APPENDIX D
Minutes of Stakeholder Meetings
and Staff Team Meetings

PROJECT: Longwood Road – Schedule C - Class Environmental Assessment
PROGRESS MEETING NO: MTO Coordination Meeting #1
FILE NO.: 7621
DATE: February 8, 2010 **TIME:** 2:00 p.m.
PLACE: Hamilton City Centre – DPW Offices
PRESENT: Lorissa Skrypniak - Public Works
Ron Gallo - Public Works
Tanya McKenna - Public Works
Steve Robichaud - Planning
Bart Brosseau - Public Works
David Cuming - Urban Design
Khaldoon Ahmad - Urban Design
Richard Yeung - MTO Corridor Control
Greg Roszler - MTO Corridor Control
Philip Weber - Ourston Roundabouts Canada
Ted Gill - MRC
PURPOSE: Coordination with MTO

PROJECT: Longwood Road – Schedule C - Class Environmental Assessment

PROJECT: Longwood Road – Schedule C - Class Environmental Assessment

LONGWOOD ROAD

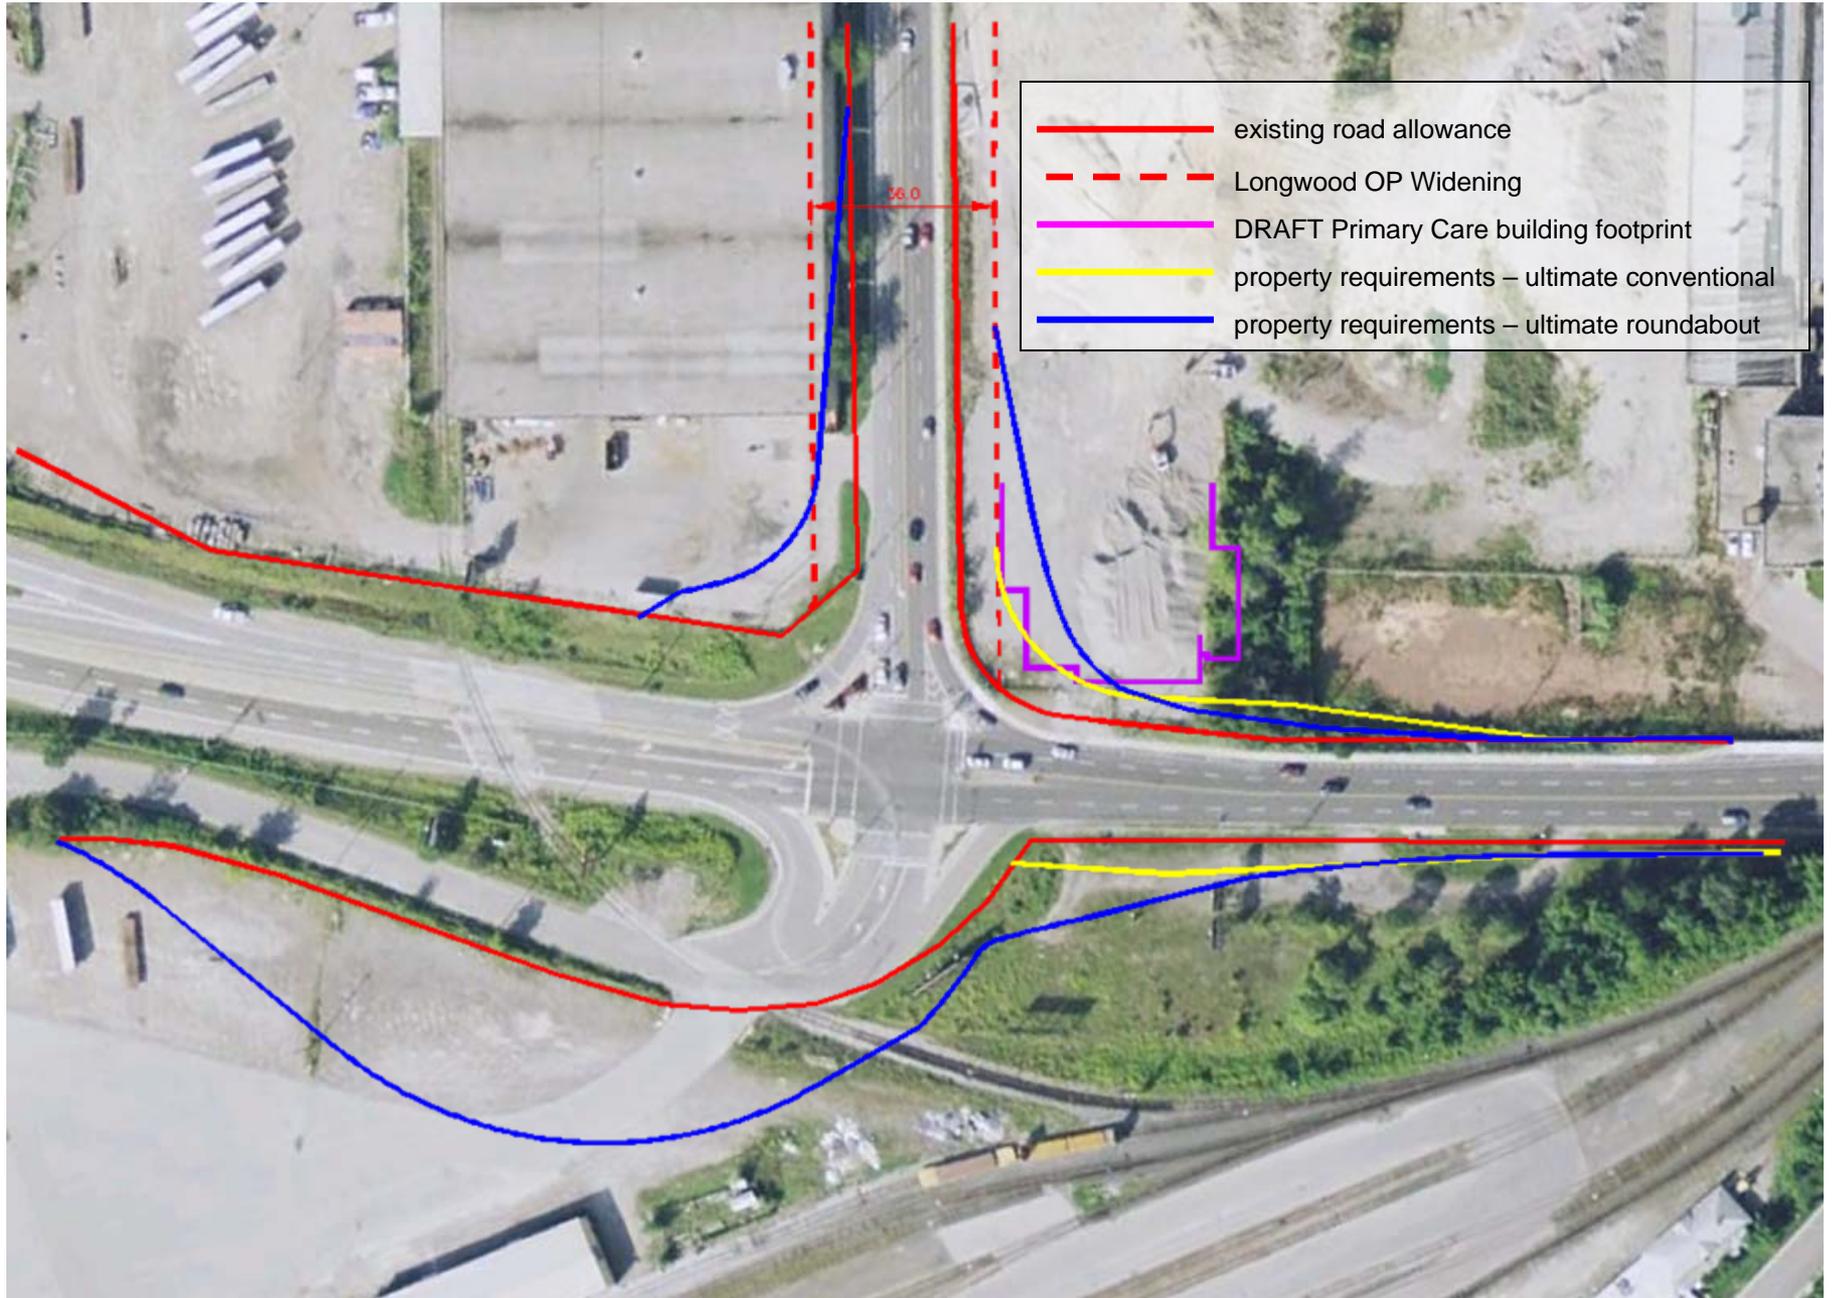
- Ted Gill presented a series of PowerPoint illustrations showing the property requirements on Longwood Road to give effect to the Official Plan designation of 36m, the property requirements for an ultimate conventional intersection design, and the property requirements for an ultimate roundabout design incorporating right turn slip lanes for WB to

- NB movements and SB to EB movements. The proposed location of the McMaster Primary Care Facility was also shown.
- Zach Douglas objected to the extent of the widenings for the ultimate roundabout configuration because of the impact on McMaster Innovation Park developable land on the east side of Longwood Road. He indicated that MIP has more flexibility with respect to additional property requirements in the NW quadrant on the west side of Longwood Road between the existing building and Aberdeen Avenue.

- Orest Rojic and Richard Yeung expressed concerns with the slip ramps, indicating that weaving distances would be very short. Phil Weber provided the rationale for the design, indicating that “smart ramp” design could possibly be used for the ramp designs, and that no ramps would be required for a number of years. Phil described how pedestrians and cyclists would be accommodated. Tanya McKenna explained that a signal was to be provided at Studholme where pedestrians and cyclists could cross Aberdeen.

- Discussions occurred re shifting the roundabout southerly and westerly, but there was a constraint with respect to truck movements and loading at the building located on the CP lands. Phil Weber stated that when designing a roundabout, the design is optimized for entry and departure angles etc., after which variations in location by a relatively modest distance (usually just several metres) can be considered to address specific constraints. It was concluded that the study team will investigate the extent to which a southwesterly shift could occur.
